**BUILDINGS 5 & 6
RENOVATIONS**

DSA BACK-CHECK

EXTERIOR ELEVATOR
FRAMING PLANS

Drawing Number: **S2.7**

2.7B PLAN AT LEVEL +671'-0" 1/4"=1'-0"

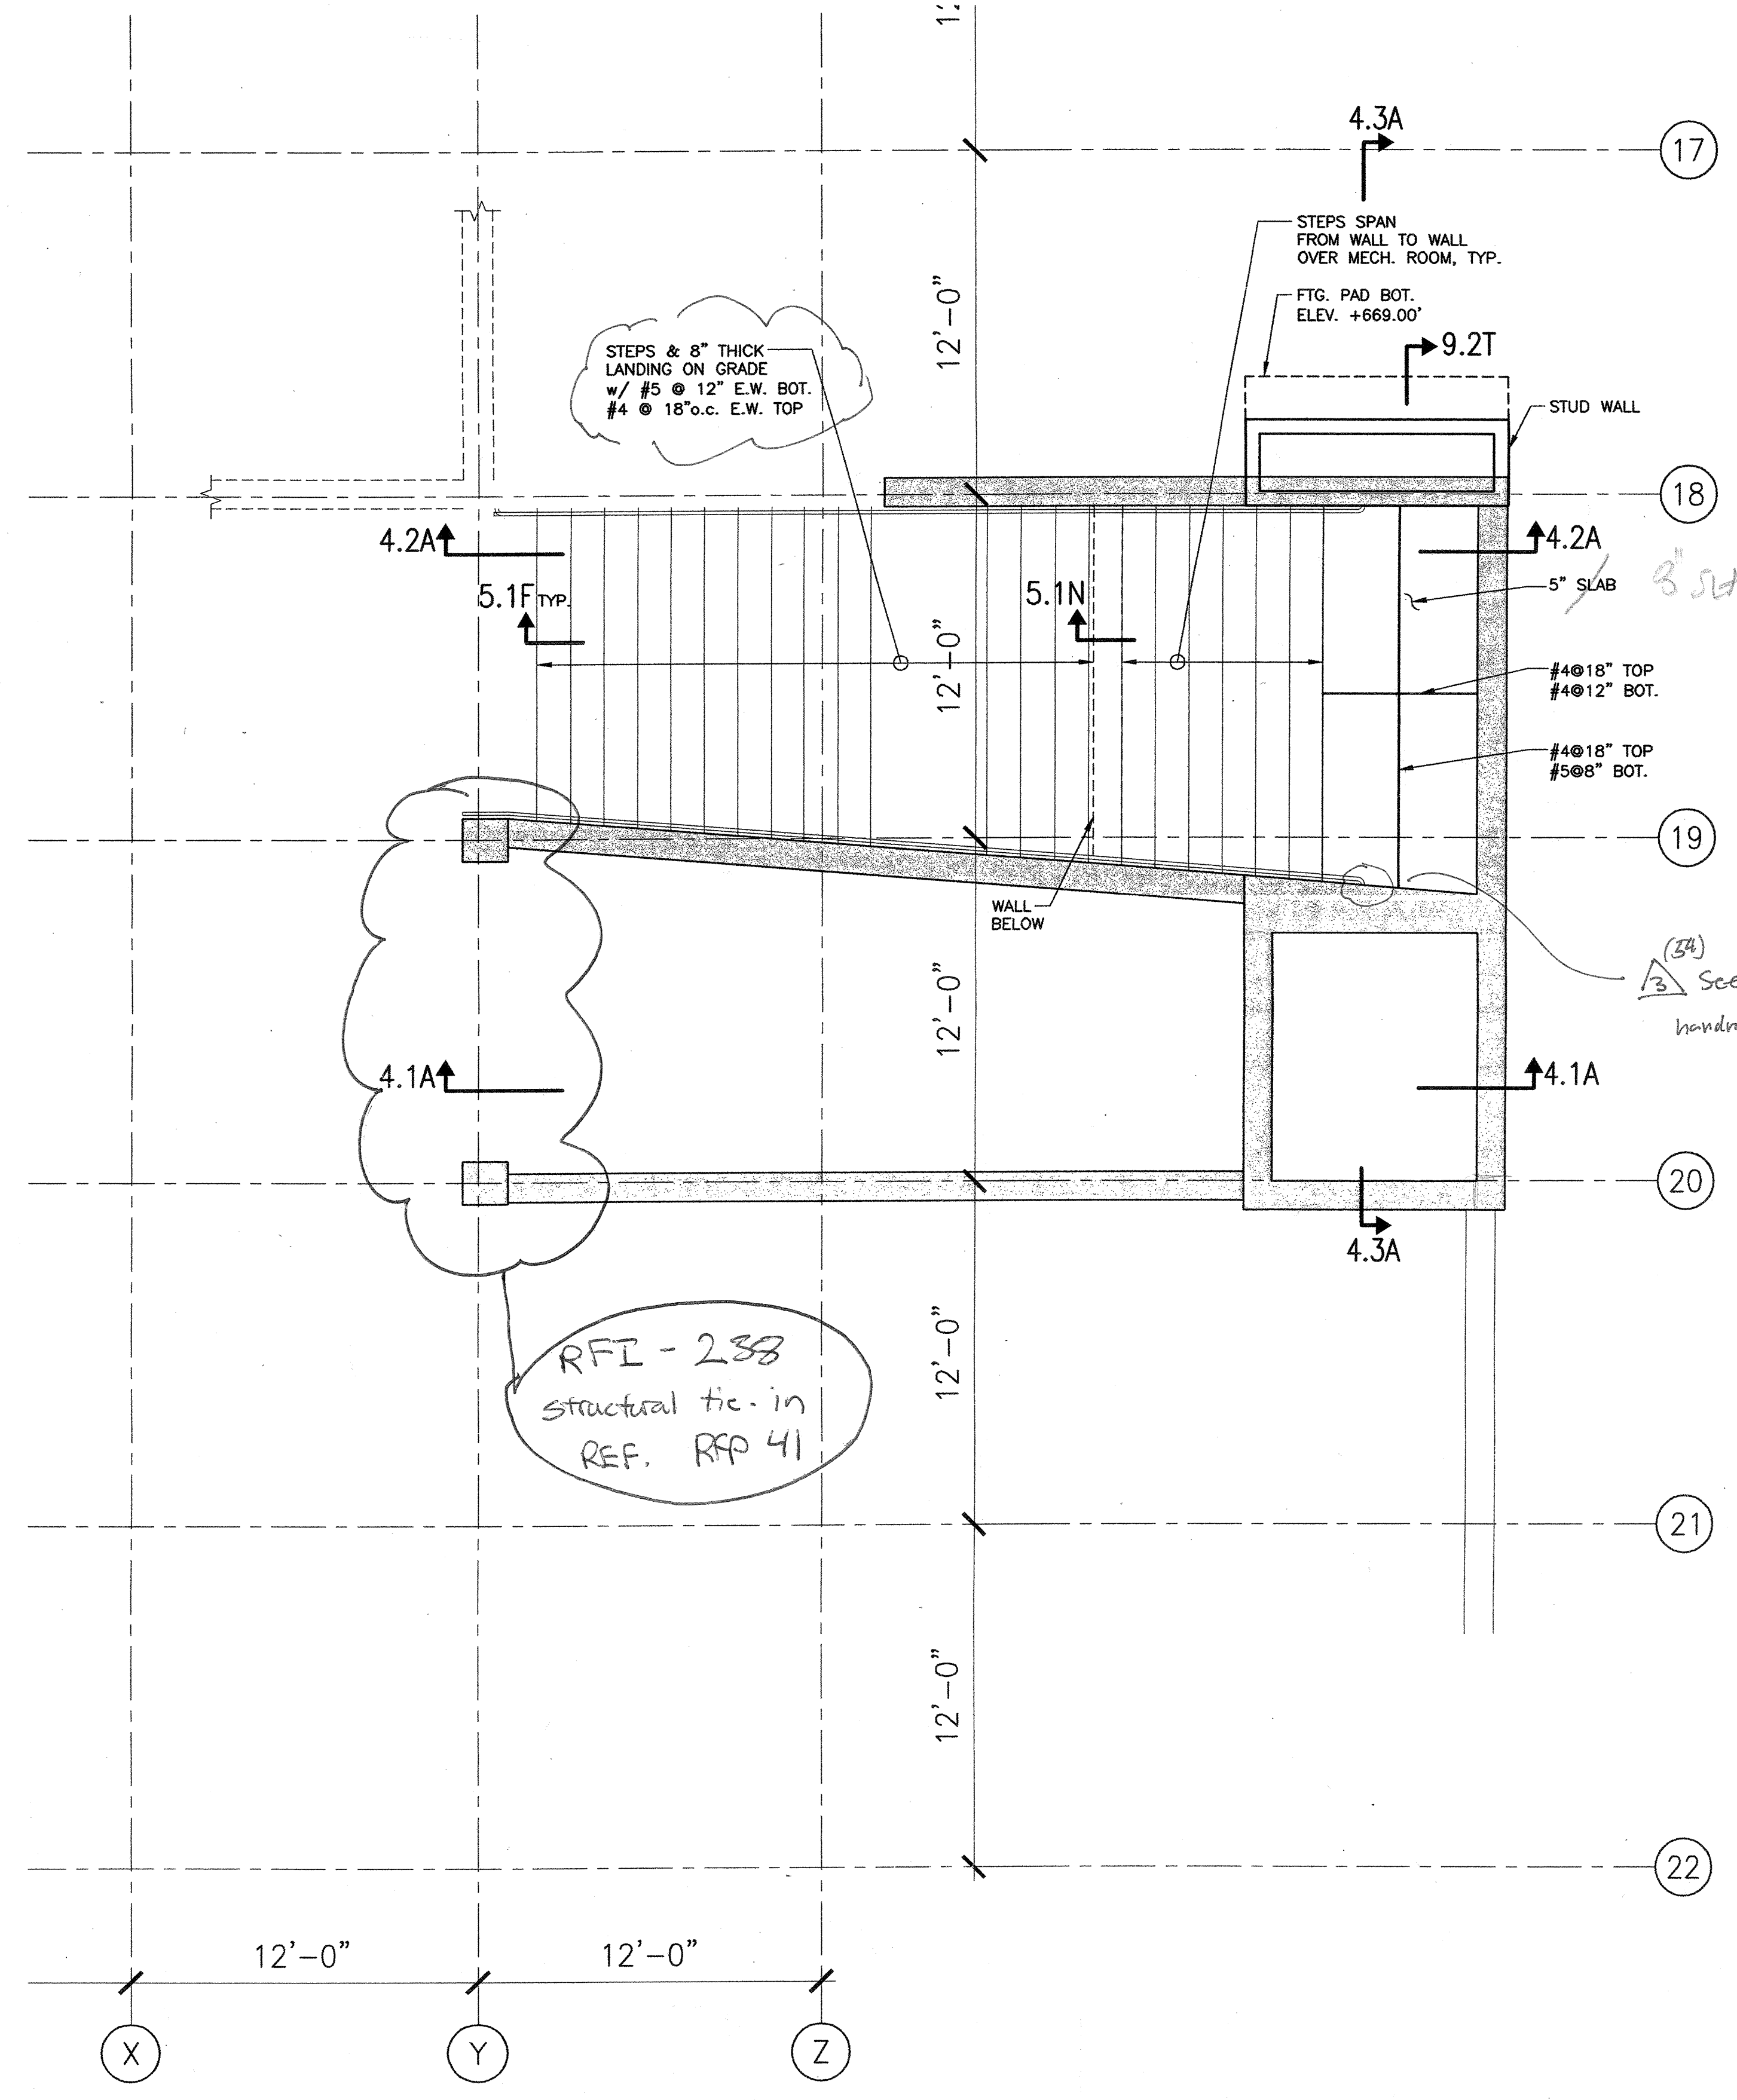
12. Detail 2.7B/S2.7 shows an 8" thick landing on grade with #5 at 12" o.c. e.w. bot. and #4 at 18" o.c. e.w. top. However, detail 2.7B/S2.7 references detail 5.1F/S5.1 which shows a 6" thick landing with c.w. top. Detail 2.7B/S2.7 also references detail 5.1F/S5.1 which shows a 6" thick landing with #4 at 12" o.c. e.w.; a 12" slab; and an 8" wall not shown on detail 4.2A/S4.2. Nor does 5.1F/S5.1 show the transition from the landing to the stairs above. Please revise detail 5.1F/S5.1 to conform and continue in further detail the design shown in plan 2.7B/S2.7 and section 4.2A/S4.2.
 Response: Use landing and reinforcement shown on section A/S4.2, which clearly defines concrete reinforcing. See plan A/S2.6 and section A/S4.2 for locations of the walls below the stairs.
